42 PHOENIX ROAD

DESIGN AND ACCESS STATEMENT

Addendum May 2016

This document is an addendum to the Design and Access Statement which was originally submitted as part of detailed planning application for student residential accommodation (2015/6383/P).

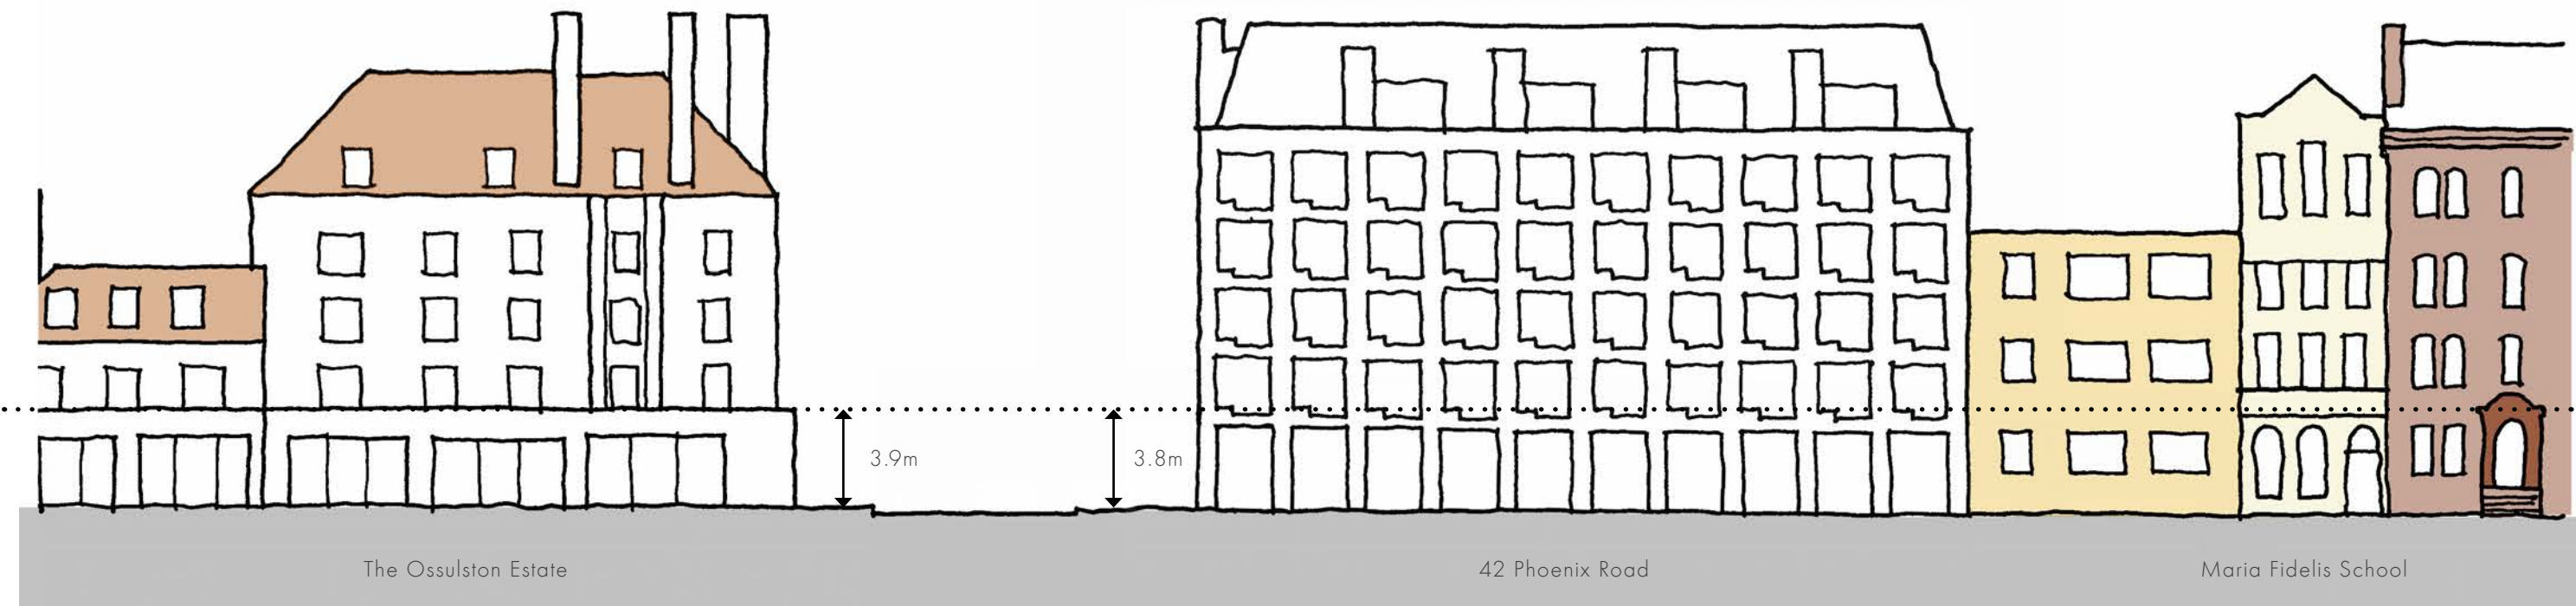
The planning application proposed a floor to ceiling height at ground level of 2.9m which is consistent with the ground floor height of the residential block, Chalton House, to the rear. At 2.9m, in the planning drawings the ground floor was 500mm taller than the typical floors above.

However, when seen in the context of nearby existing buildings, in particular the Maria Fidelis School and the Ossulston Estate, this height could be considered to be too diminished and not consistent with the context.

As a result, we propose to increase the height of the ground floor. This increase in height improves the relationship between the base of the building and its middle, setting a clear hierarchy between the public and private spaces.

Phoenix Road South - As revised proposal (not including amendments to roof height - refer to end of document)

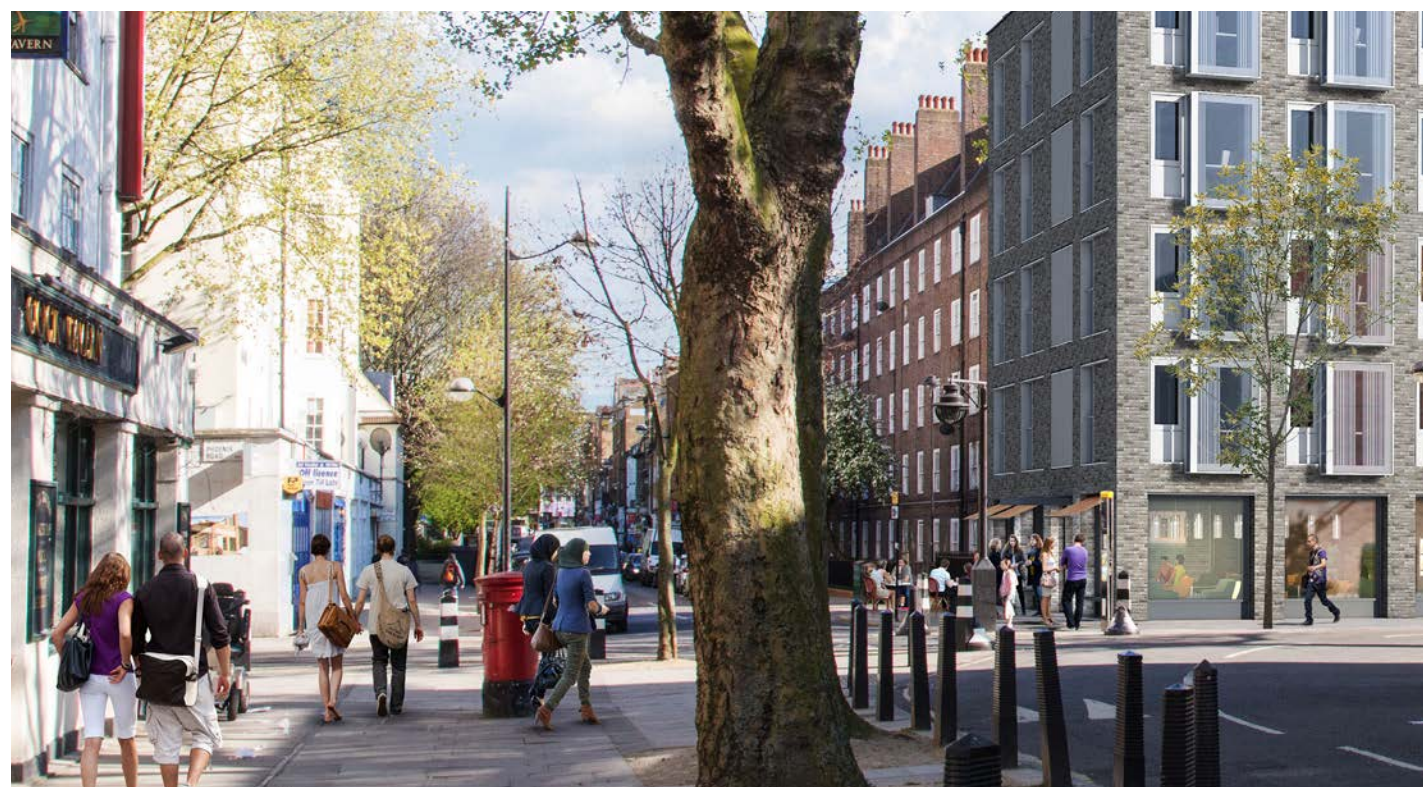
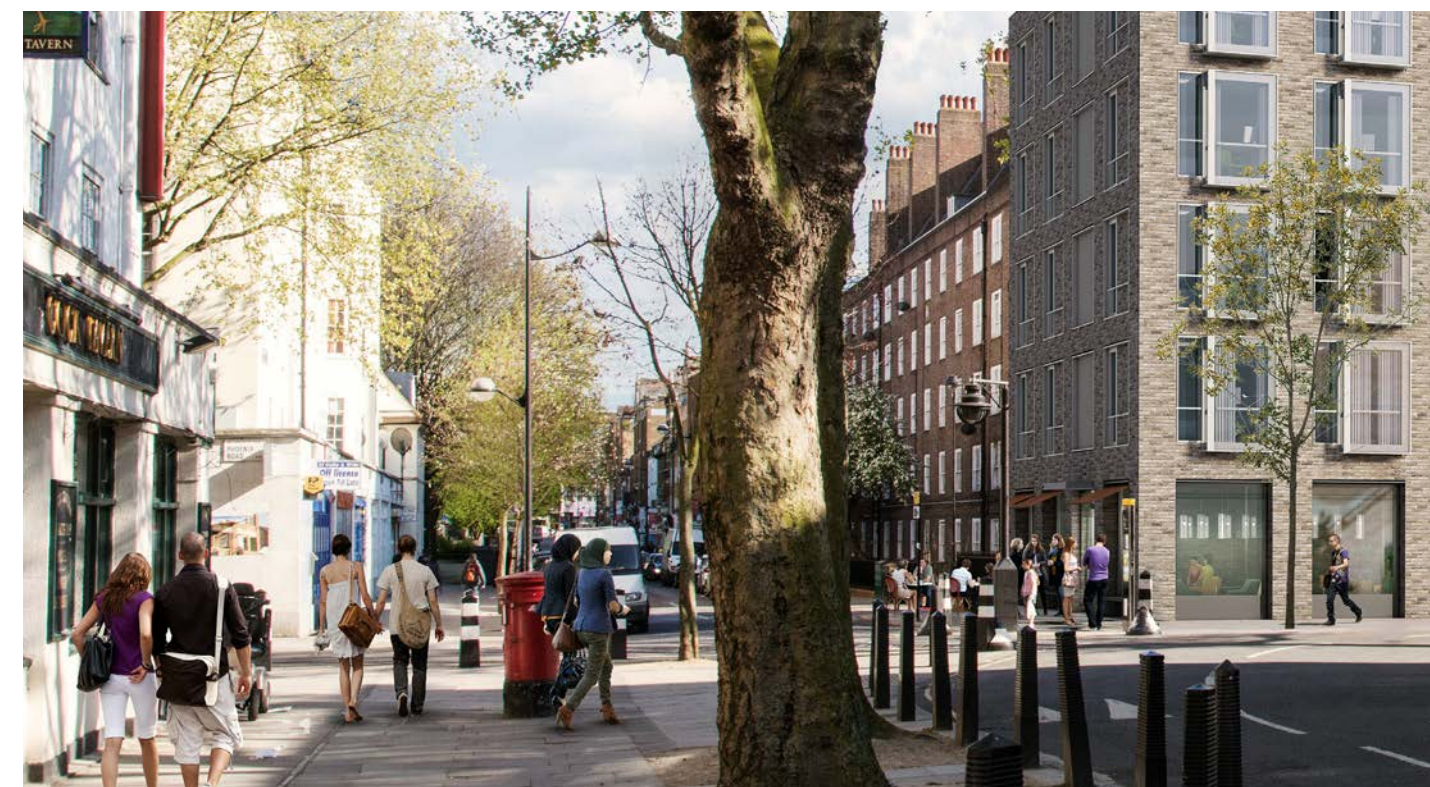
Ground floor height as submitted for planning

Raised ground floor height as revised proposal

It is proposed that the ground floor of the building is increased in height by 7 bricks (525mm). This brings the base of the building closer in line with the ground floor of the Ossulston Estate and gives the street level windows a vertical emphasis where they were previously square in shape.

3 Brick pier as per the planning application

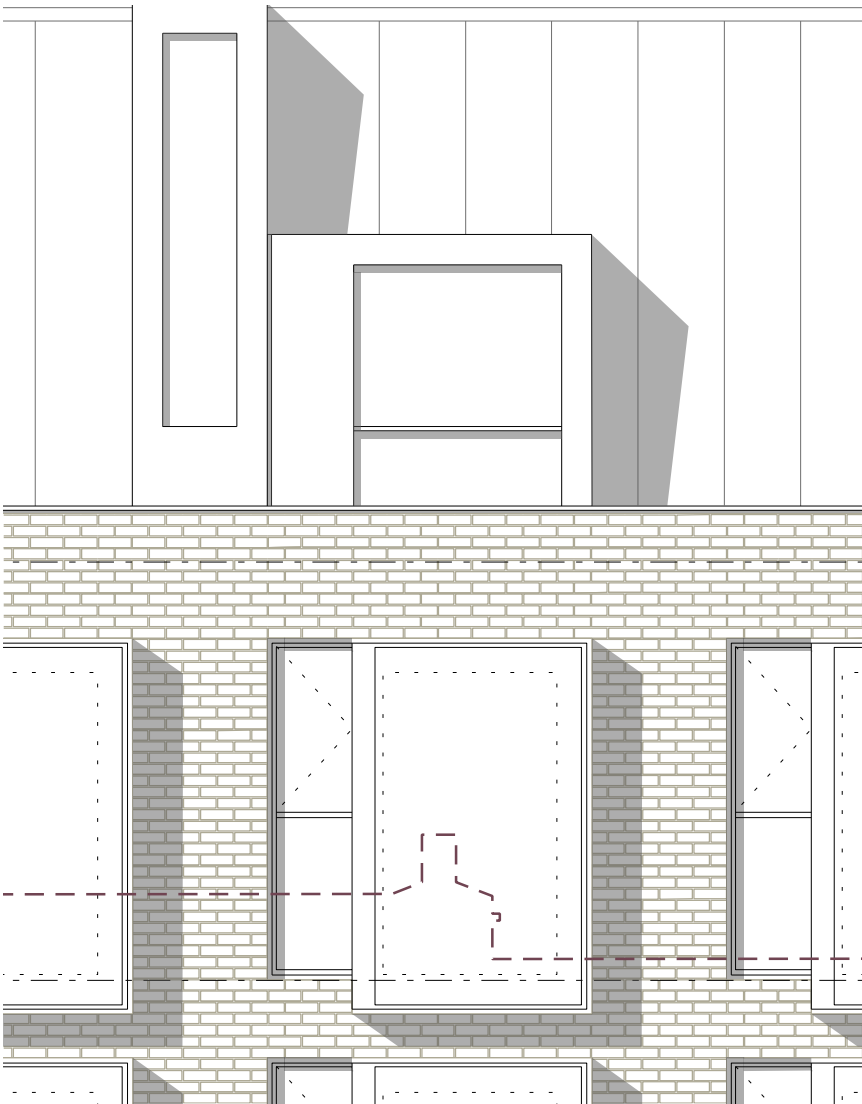
We have increased the brick piers from 3 bricks wide to 4 bricks wide on the north and south elevations. In doing so we have reduced the width of the openings. We have retained the width of the projecting bay window and decreased the width of the side window, allowing this to read more like a slot window than a door and reducing the amount of metalwork in the facade.

4 Brick pier as per the revised proposals
